PROPOSAL FOR DRAFT AMENDMENTS TO REGULATION No.13

(Braking)

Transmitted by the expert from
European Association of Automotive Suppliers (CLEPA)

Diagram 1"

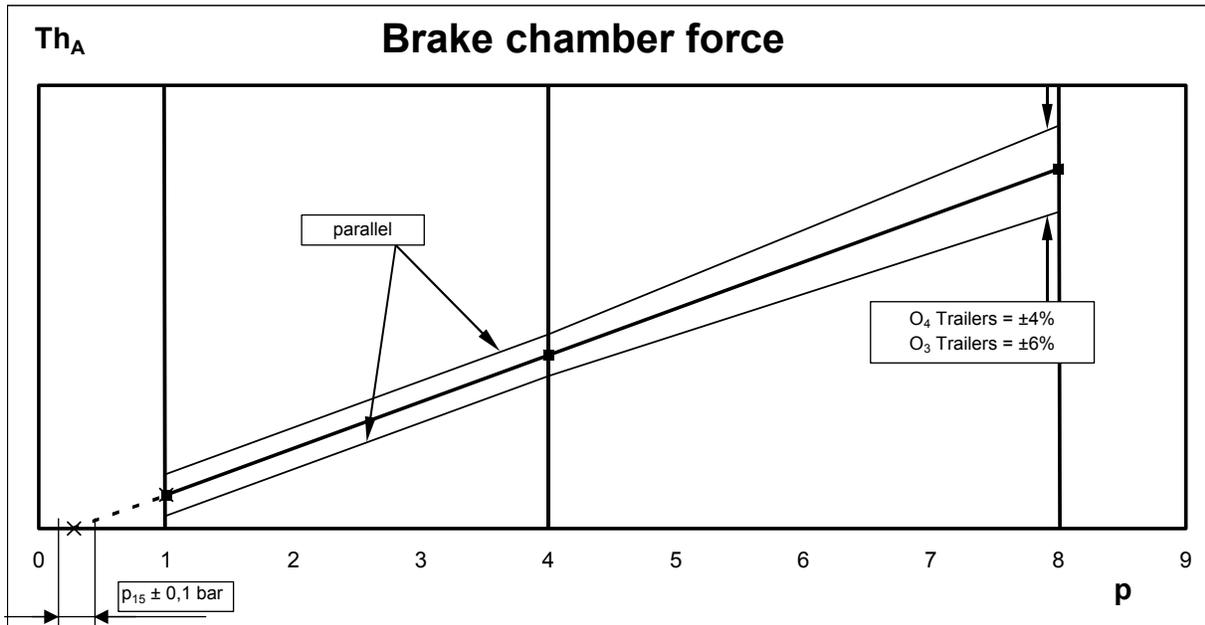
- 2.3.2. With respect to the verification of average thrust (Th_A) - $f(p)$, a graph defining the acceptable performance variation shall be constructed following the model shown in diagram 1, which is based on the manufacturers declared thrust to pressure relationship. The manufacturer shall also define the category of trailer for which the brake chamber may be used and the corresponding tolerance band applied.

To overcome this problem it is proposed that the tolerance band applied to the manufacturers declared performance is constructed in a way that at pressures $\geq 4.0\text{bar}$ the current +/- 4% tolerance remains unchanged. The tolerance band from 4.0bar to 1bar would then be parallel based on the force difference determined at 4.0bar. This tolerance band would be applied to brake chambers that may be installed on trailers of category O₄ which generally utilise the larger size of brake chamber. In the case of O₃ trailers where the use of smaller brake chambers is common a larger tolerance is required, in this case it is proposed that the above defined tolerance band has a tolerance of +/- 6%.
